CAROLINA POWER & LIGHT COMPANY

BRUNSWICK STEAM ELECTRIC PLANT

PROCEDURE TYPE: REGULATORY COMPLIANCE INSTRUCTION (RCI)
NUMBER: 02.3
PROCEDURE TITLE: TECHNICAL SPECIFICATION INTERPRETATION REQUEST,
PROCESSING, AND MAINTENANCE

FIGURE 3.4 6.1-2
PRESSURE-TEMPERATURE LIMITS
REACTOR VESSEL

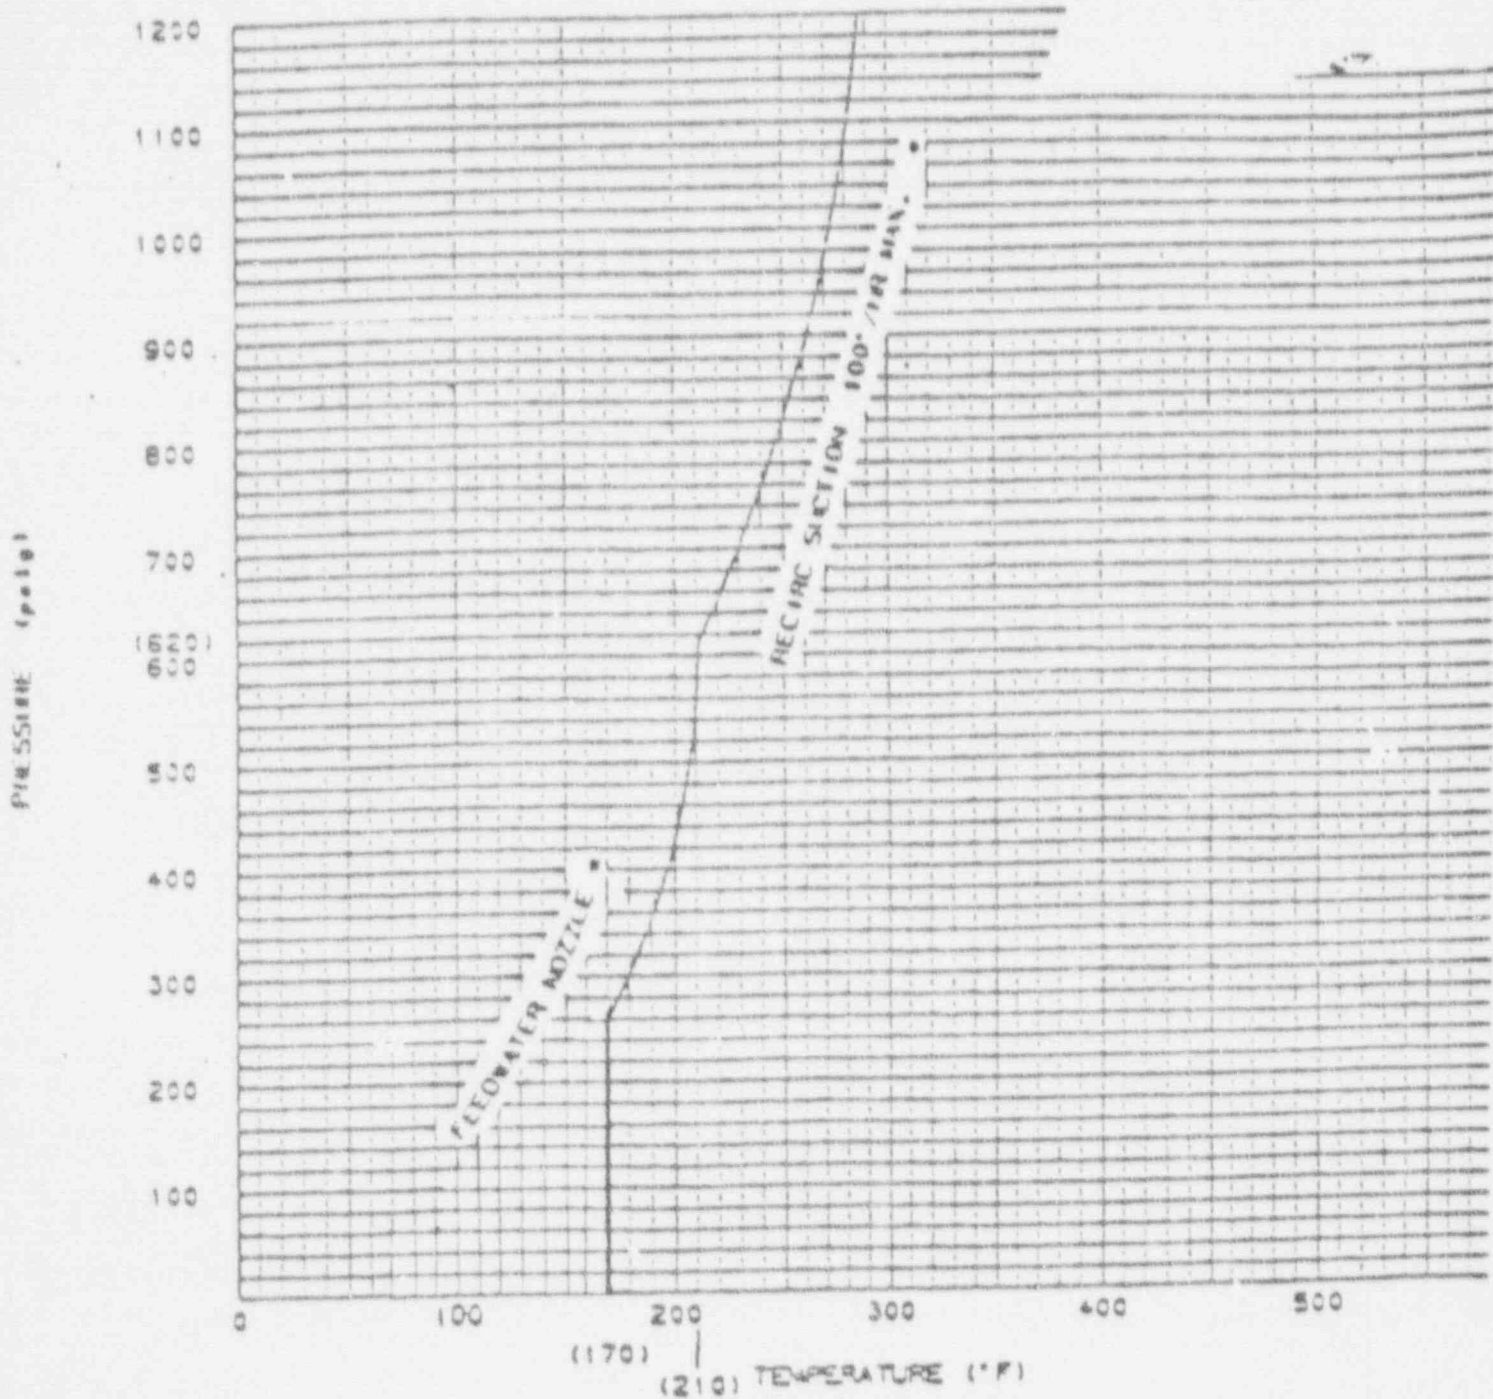
Revision 5 to this TSI is being issued to implement the latest Unit 1 pressure/temperature curve for Normal Operation With Core Critical (Figure 3.4.6.1-2). This pressure-temperature curve has been revised using the latest NRC guidelines along with actual neutron flux/fluence data.

Revision 6 of this TSI is being issued to revise and clarify the criticality curve for Unit 1 that was transmitted via revision 5. The original criticality curve for Unit 1 ends at approximately 153 degrees on the x-axis and 460 psig on the y-axis (Ref. Figure 3.4.6.1-2 of Tech. Specs.). In revision 5 of this TSI it was determined that the area below the above x-y coordinates was an undefined area. The lower portion of the curve was therefore plotted using the latest NRC guidelines. Regulatory Compliance has determined that the original Unit 1 curve should be drawn straight down from the above listed coordinates. This revision revises the curve issued via revision 5 by removing the cross-hatched area and by adding the lower portion of the curve. The

limit has been set at 170° F instead of 153° F to account for neutron embrittlement. This revision will suffice for the interim until the permanent Technical Specification Change Request, which includes the cross-hatched area, is approved by the NRC.
